CITY OF West Linn

STAFF REPORT FOR THE HISTORIC REVIEW BOARD

FILE NUMBER: DR-23-01

REQUEST: Provide a recommendation to the Planning Commission regarding a Class II Design Review at 1919 & 1949 Willamette Falls Drive

1 GROUND FLOOR PLAN + WILLAMETTE FALLS DRIVE ELEVATION

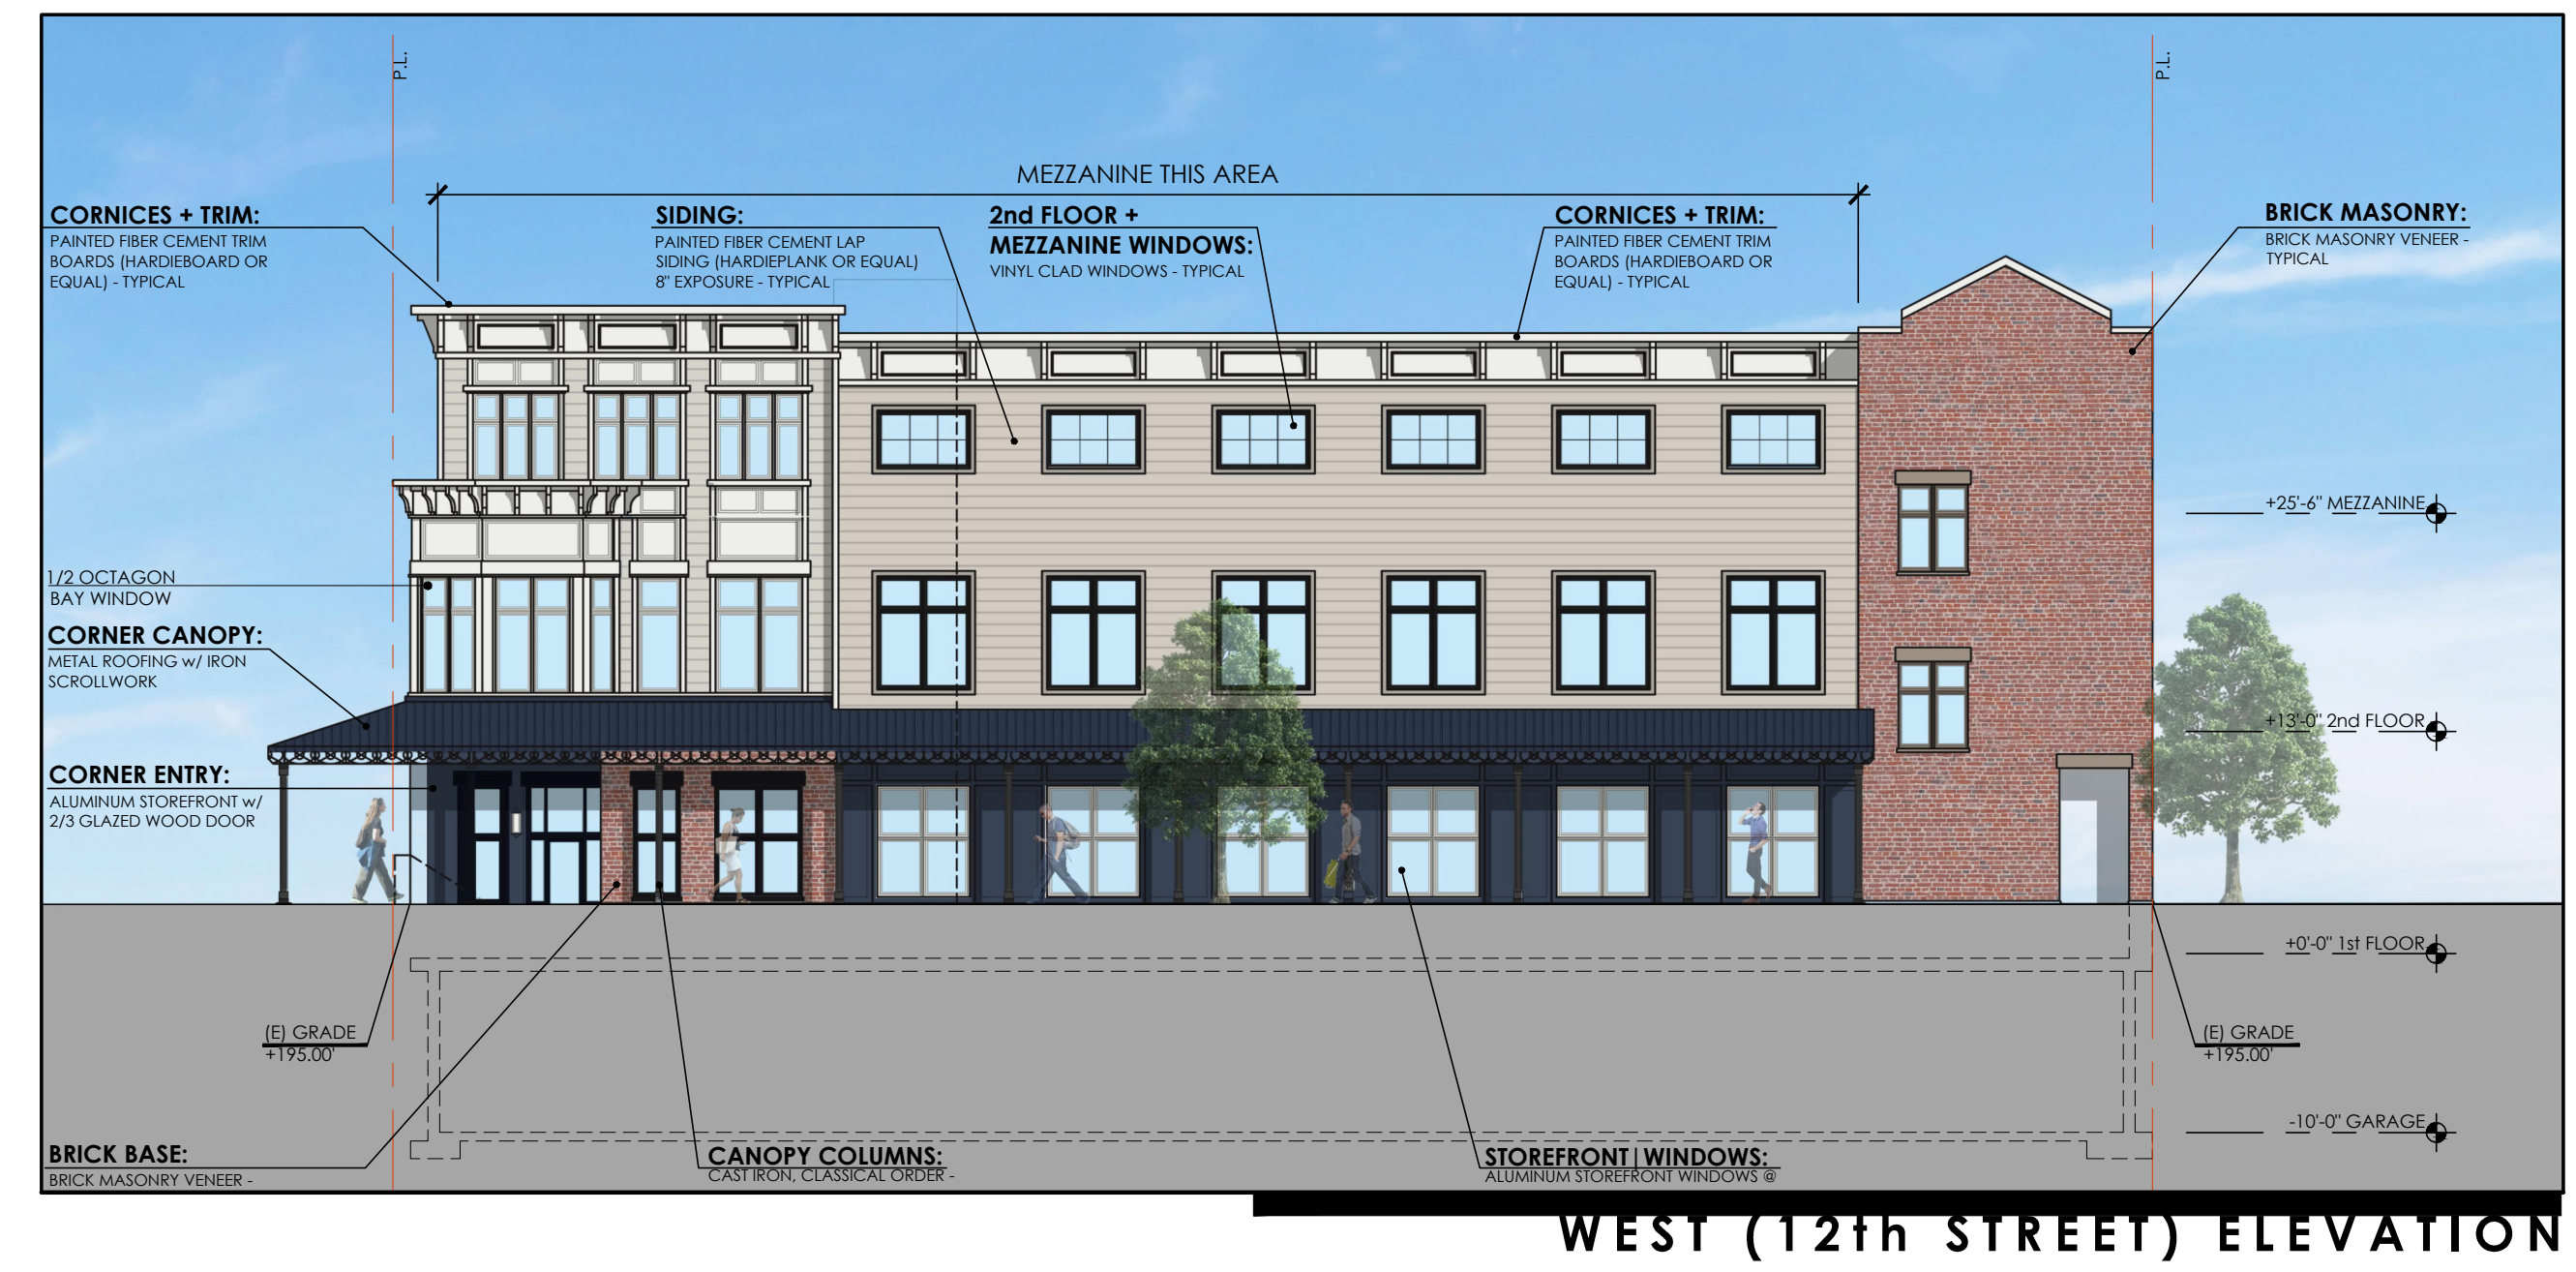
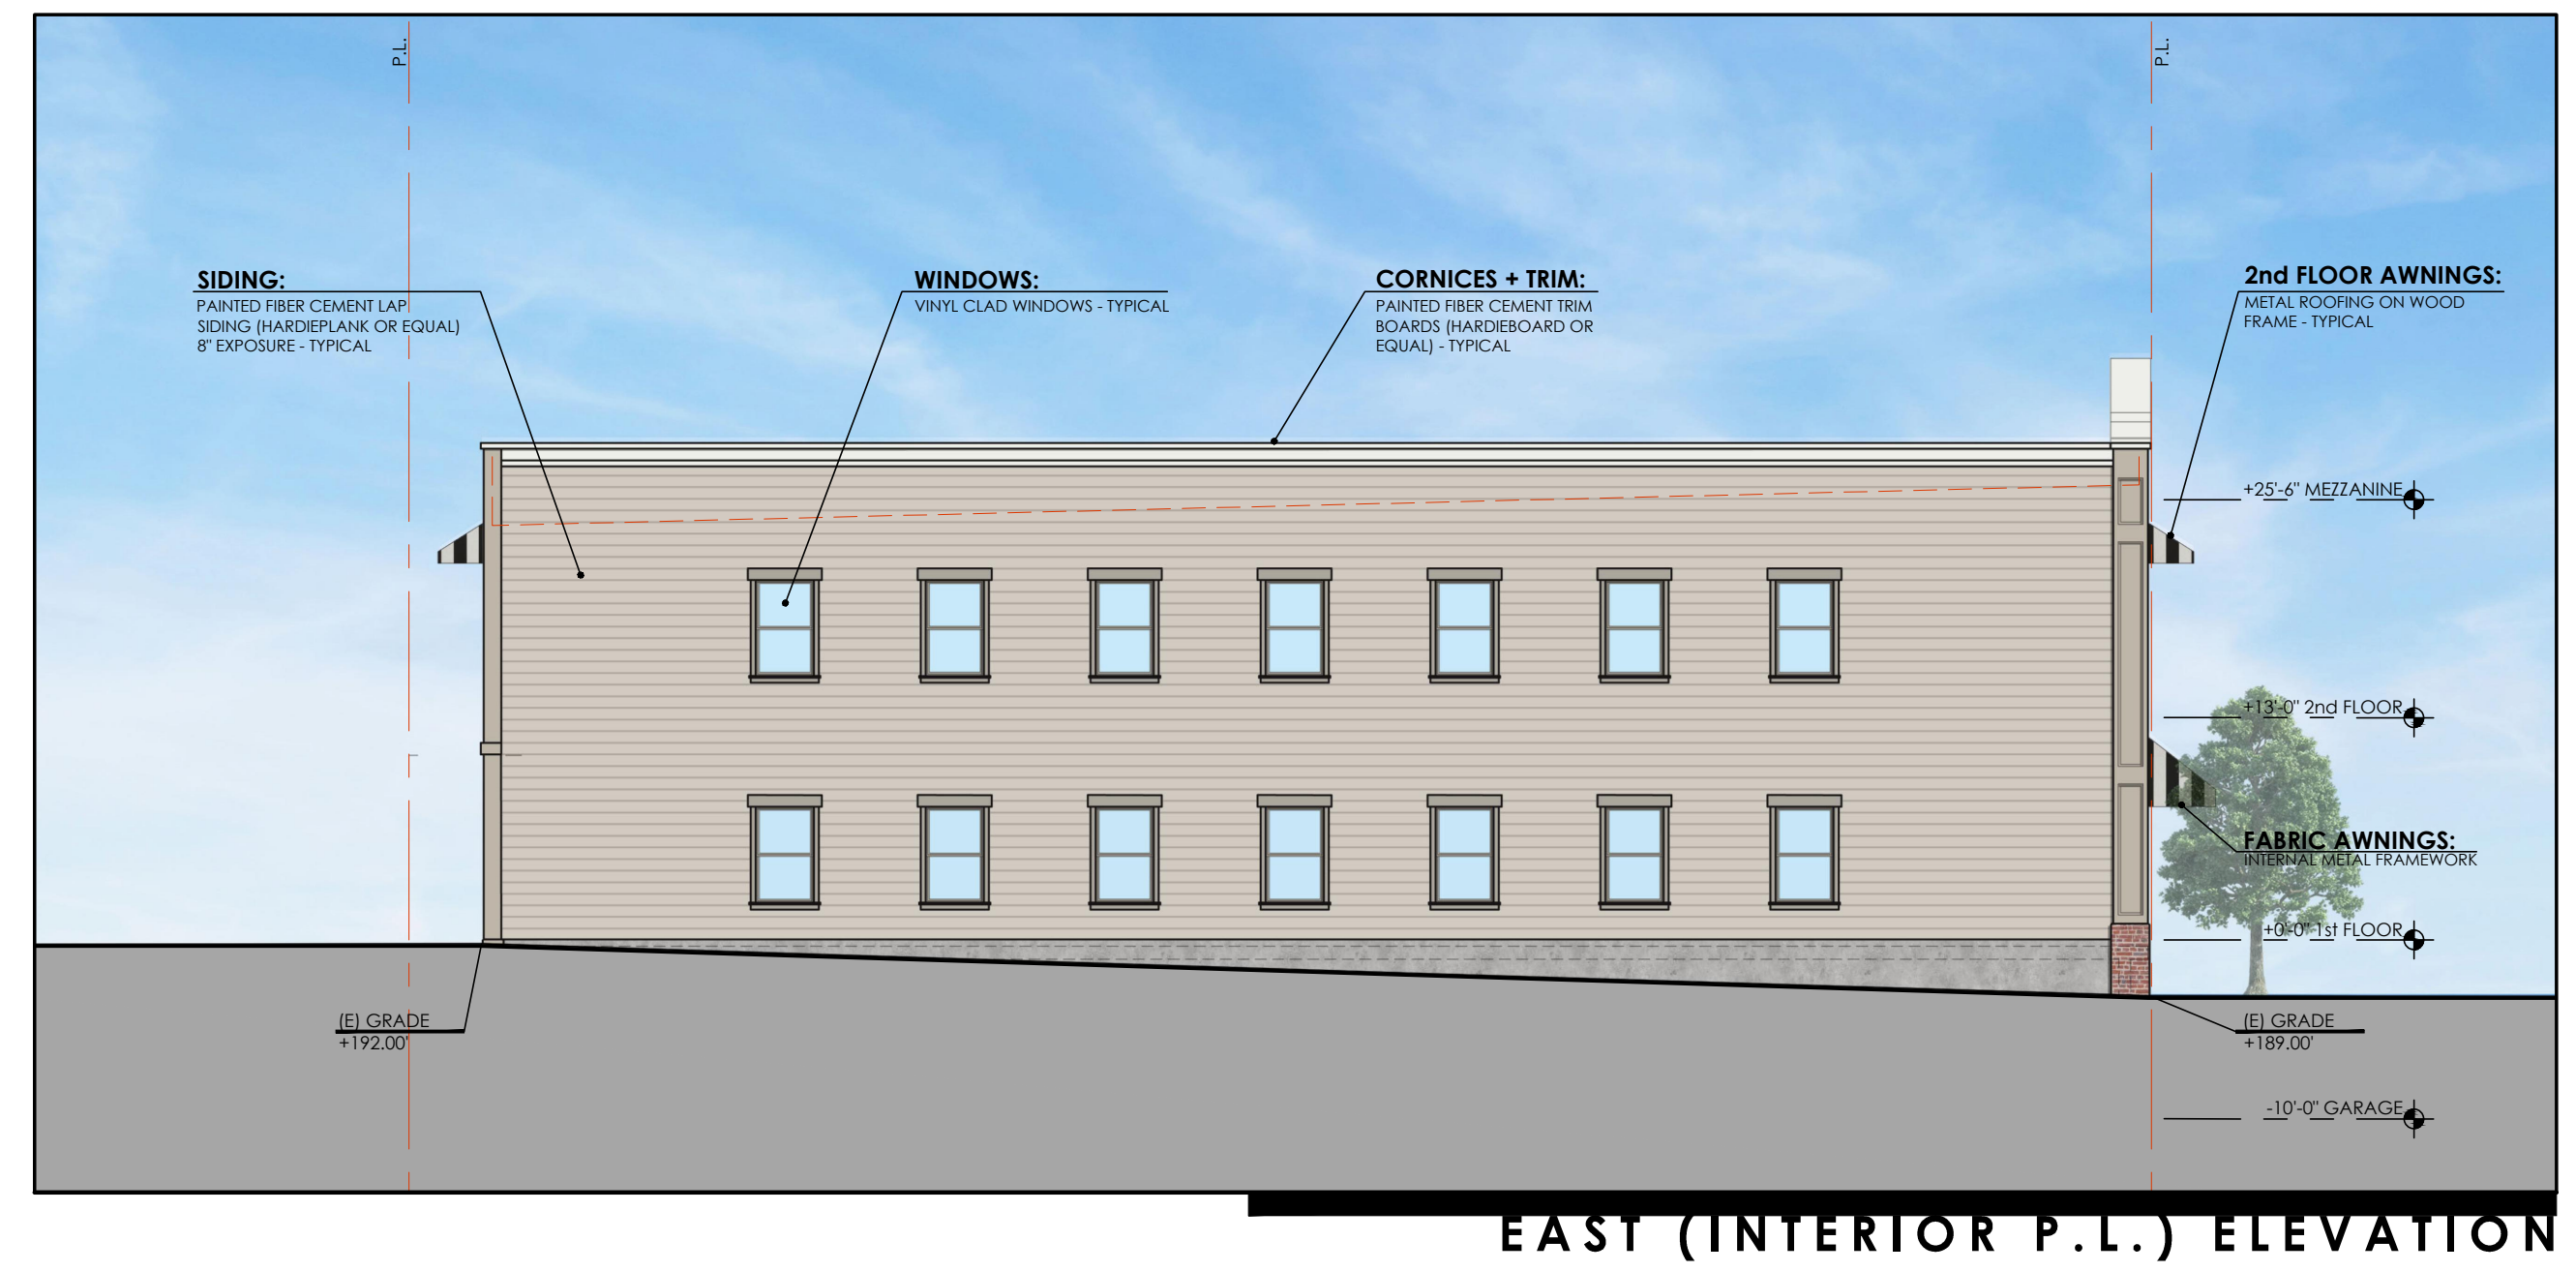
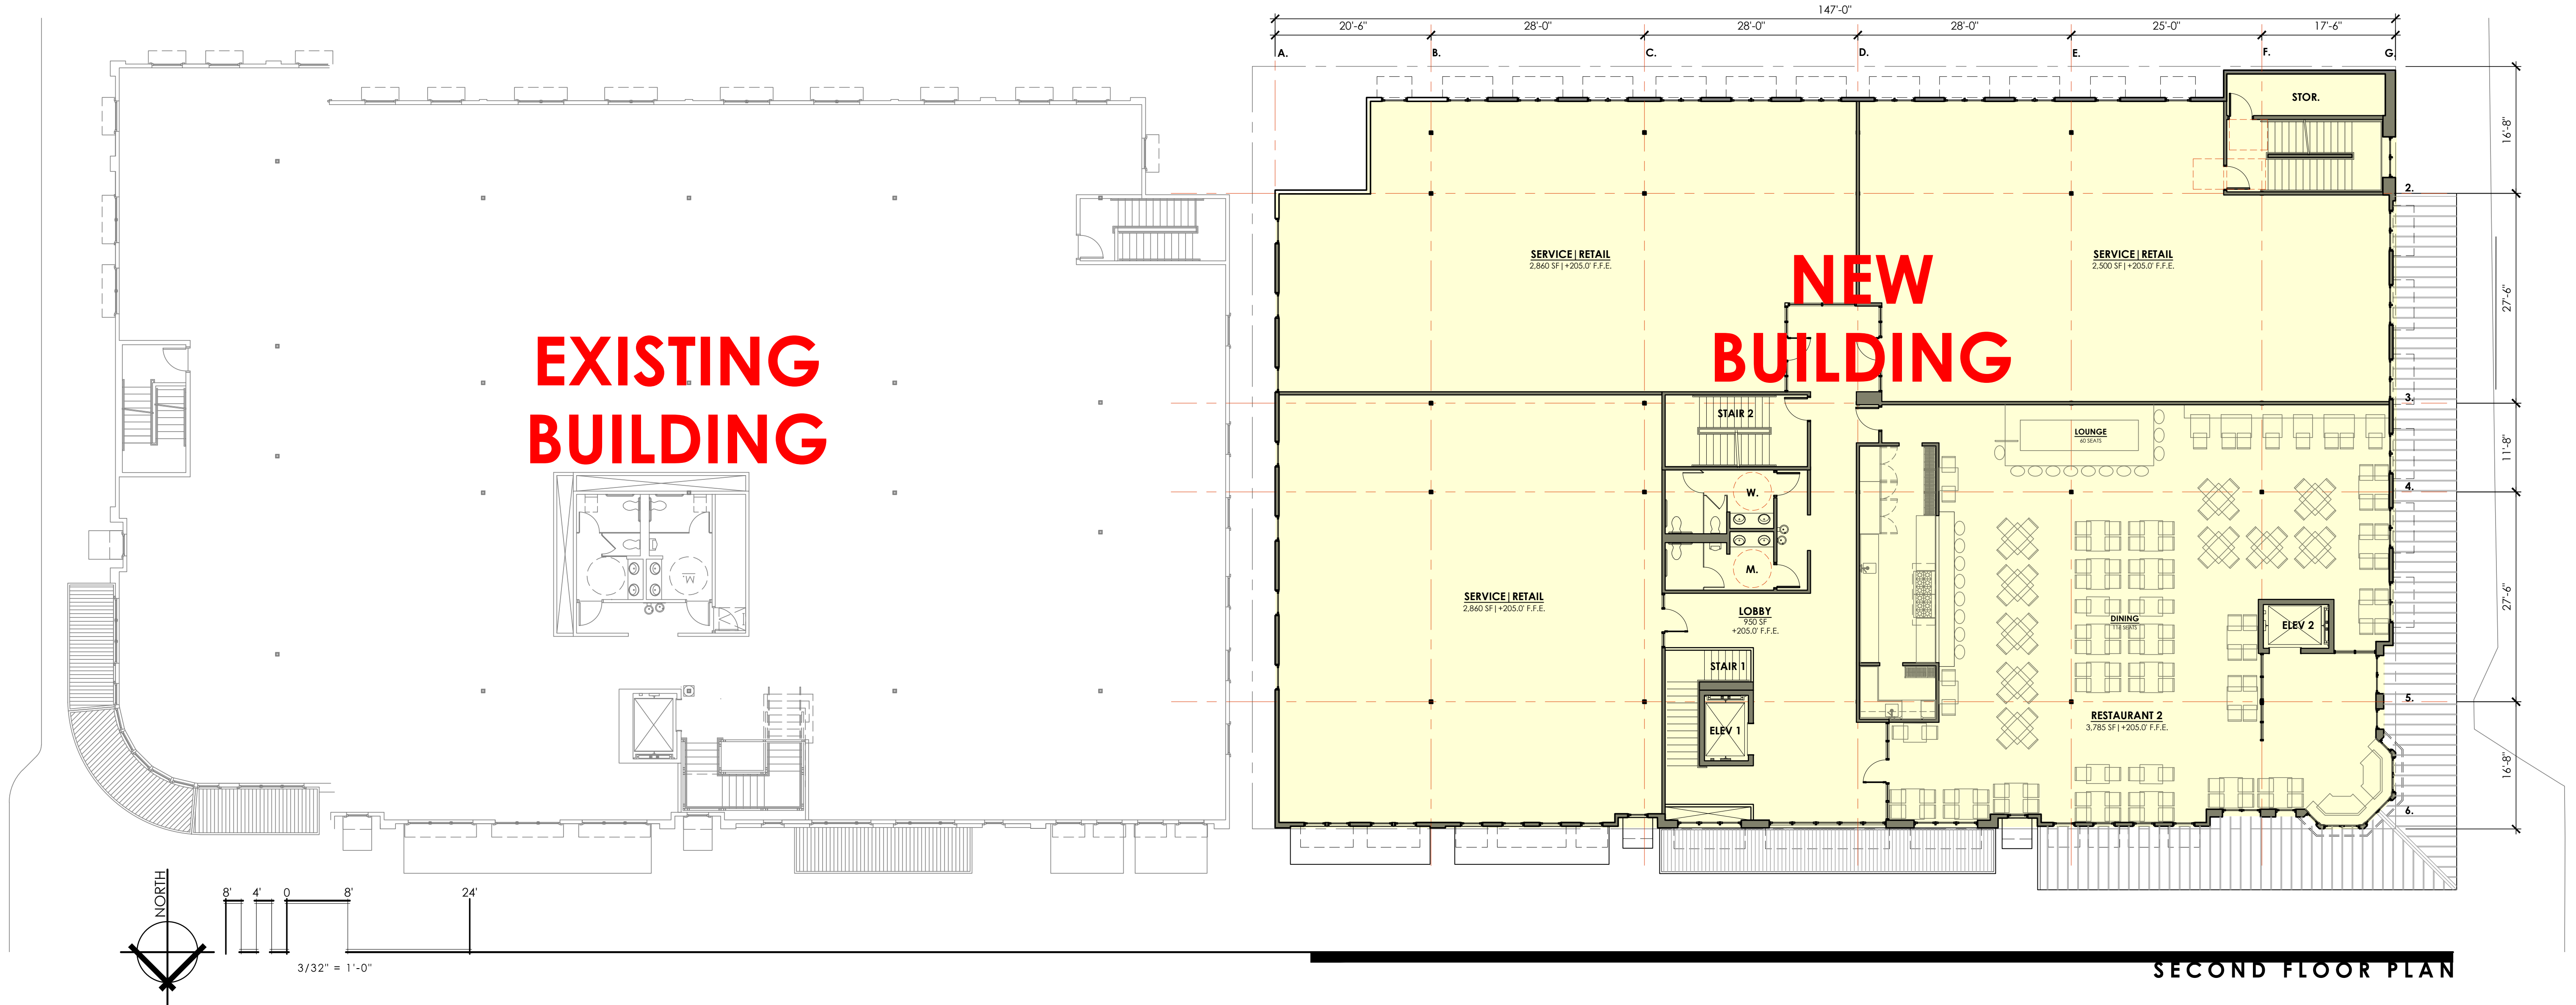
- b. Due to concerns about potential utility conflicts with the pillars proposed along Willamette Falls Drive, please provide a detail in the plans showing how the posts will be anchored to the sidewalk. Will the posts be embedded in the sidewalk or just anchored/bolted down at the surface of the sidewalk? There may need to be 2 different anchoring details – one for wherever the posts are anchored to concrete and one for where the posts are anchored in landscaped area (i.e. along 12th St.).

- c. Please provide a proposed outdoor seating layout along both Willamette Falls Drive and 12th Street, including clear demarcation of the ADA path.

The Exhibit "1949 MIXED USE.1949 WILLAMETTE FALLS DRIVE.04_12TH STREET ELEVATION (0420)" has been updated to include a footing detail for the canopy posts. The design proposes that the existing sidewalk be removed to the nearest joints, an approximately 3' x 3' x 12'd. footing be poured, and the sidewalk poured back to match the adjacent.

These footings have been shown on the Ground Floor Plan (see "1949 MIXED USE.1949 WILLAMETTE FALLS DRIVE.03_WFD ELEVATION (0420)"), along with the current site utilities. As shown, there should be little chance of conflict. In addition, the bottom of the footings are proposed at approximately 20" below grade, which should place them well above any utility lines nearby.

The Exhibit "1949 MIXED USE.1949 WILLAMETTE FALLS DRIVE.03_WFD ELEVATION (0420)" exhibit has been updated to show a possible outdoor seating layout. Any outdoor seating would be required to conform to the CDC Section 7.950 "Sidewalk Café Program".
